Title  
 J AND K MODULE CARD

Size B Document Number STC1000A.SCH Rev 00

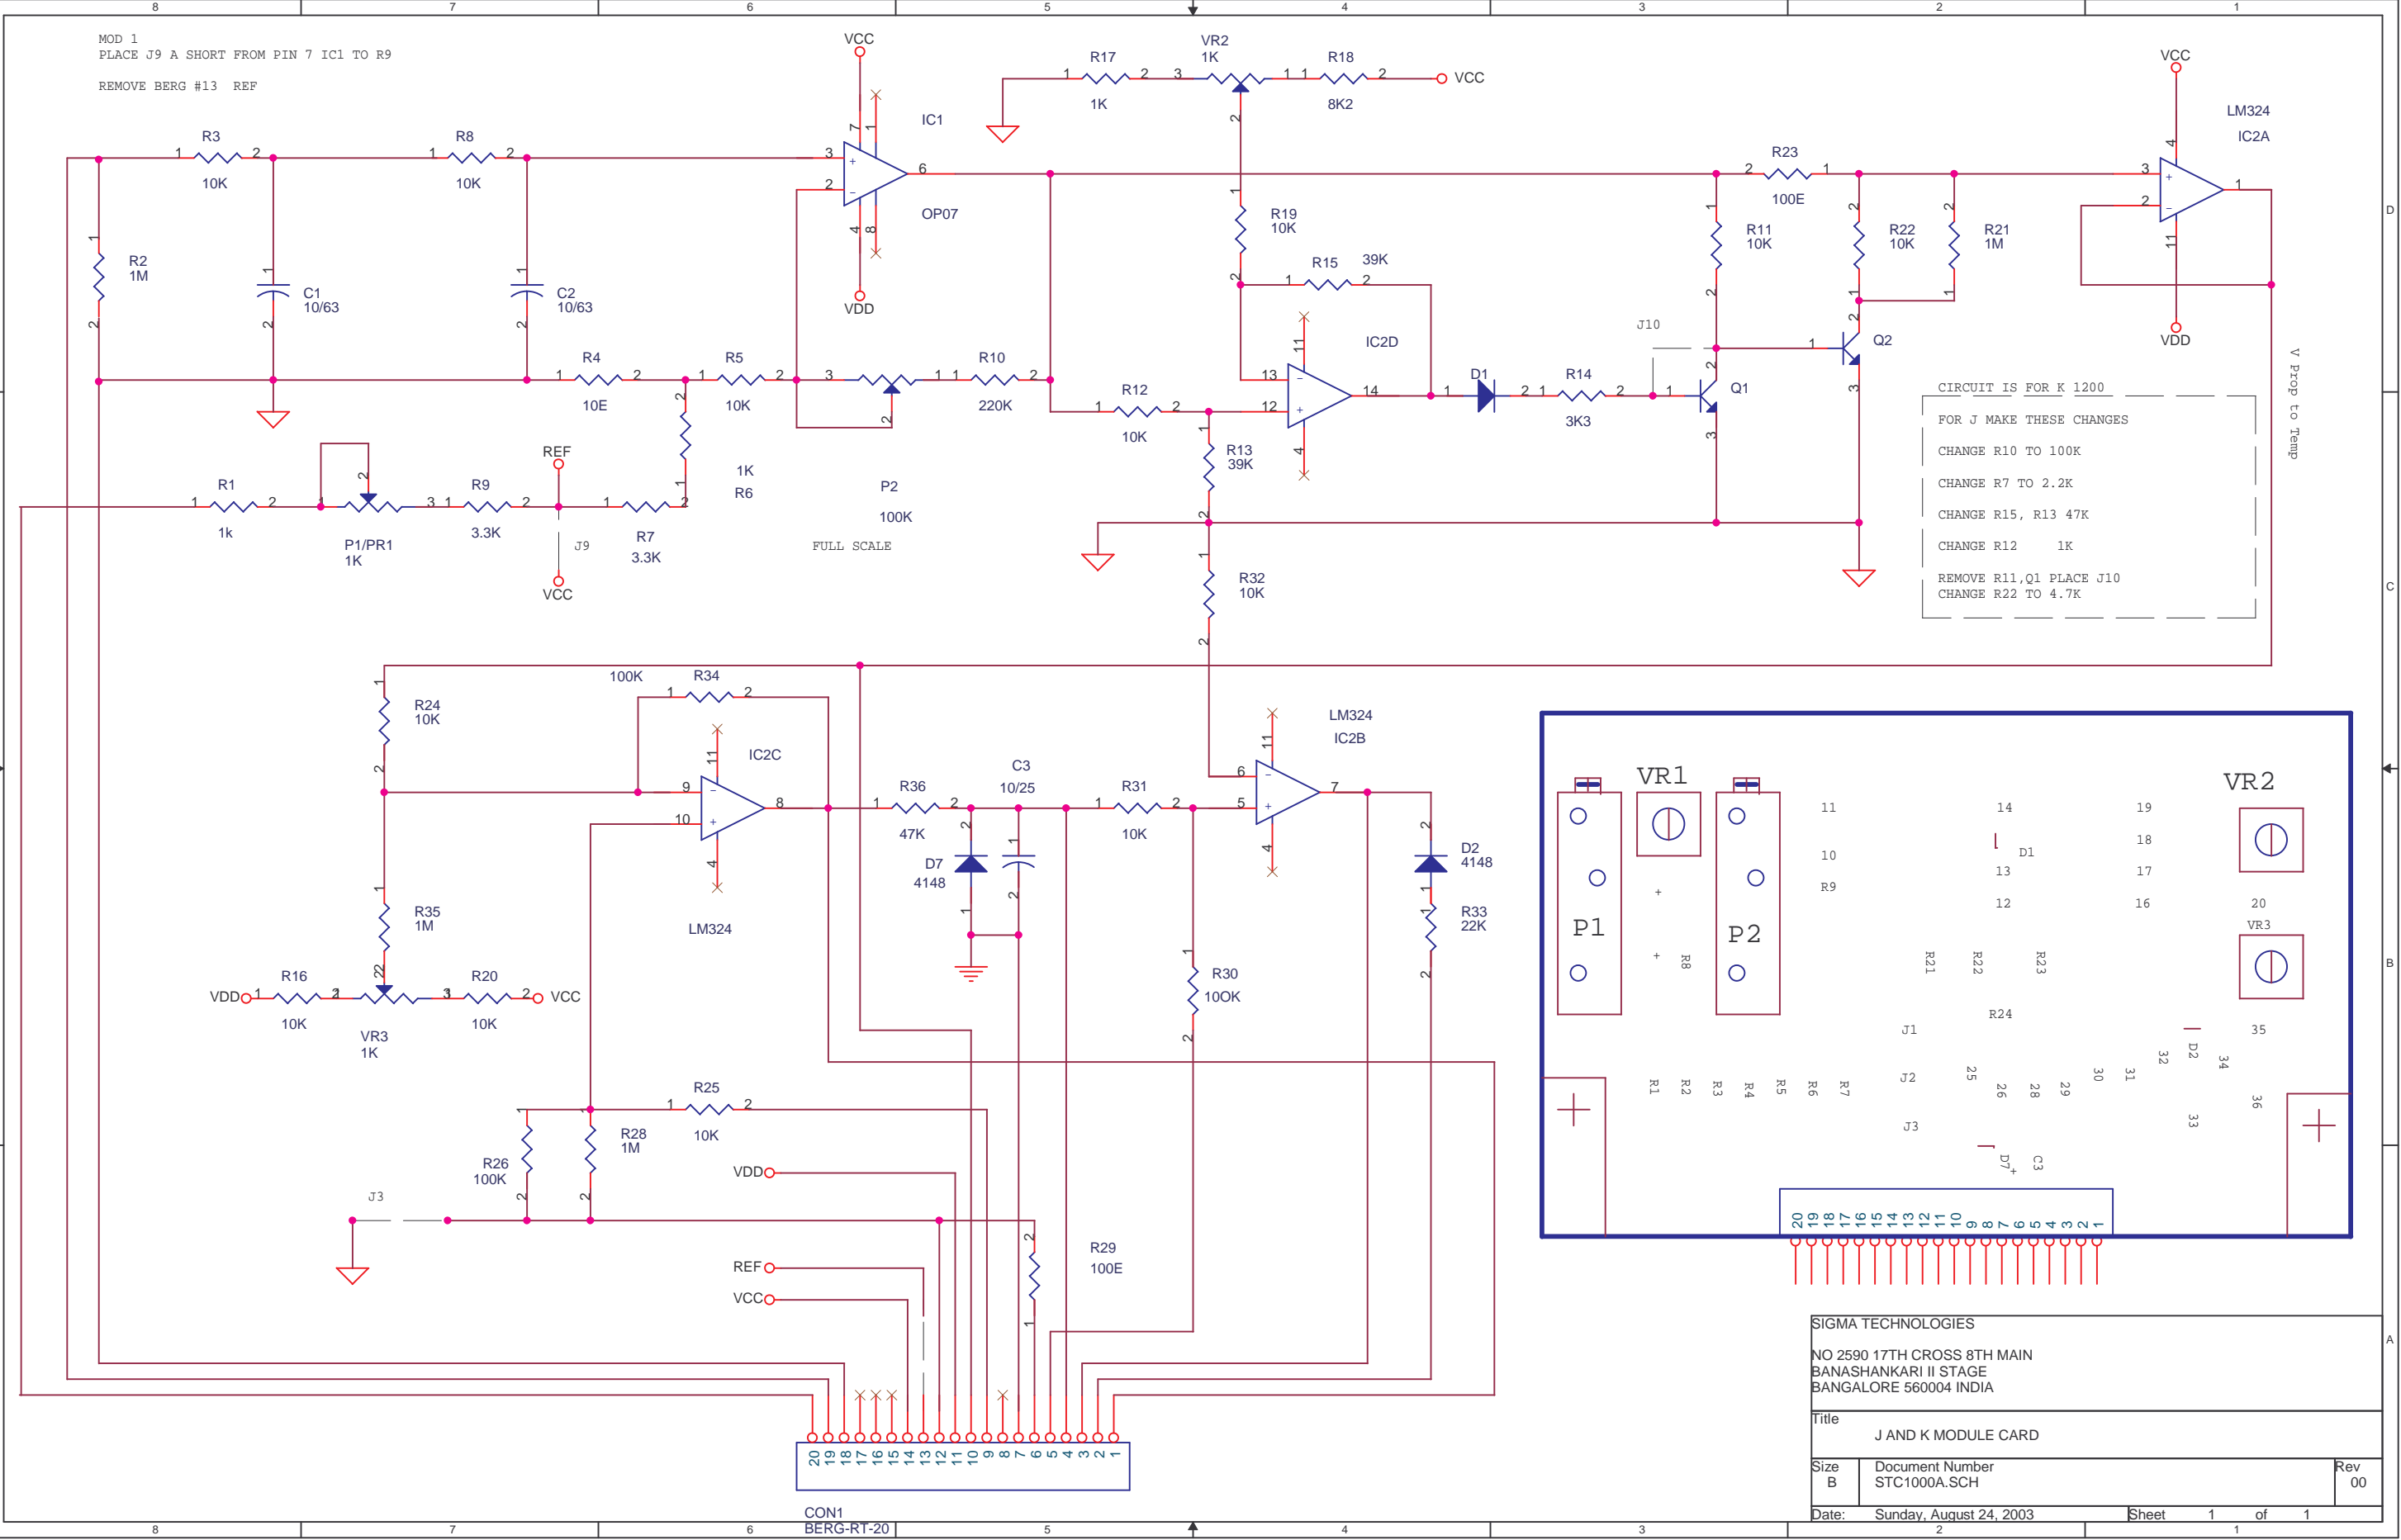
MOD 1  
 PLACE J9 A SHORT FROM PIN 7 IC1 TO R9  
 REMOVE BERG #13 REF

CIRCUIT IS FOR K 1200  
 FOR J MAKE THESE CHANGES  
 CHANGE R10 TO 100K  
 CHANGE R7 TO 2.2K  
 CHANGE R15, R13 47K  
 CHANGE R12 1K  
 REMOVE R11, Q1 PLACE J10  
 CHANGE R22 TO 4.7K
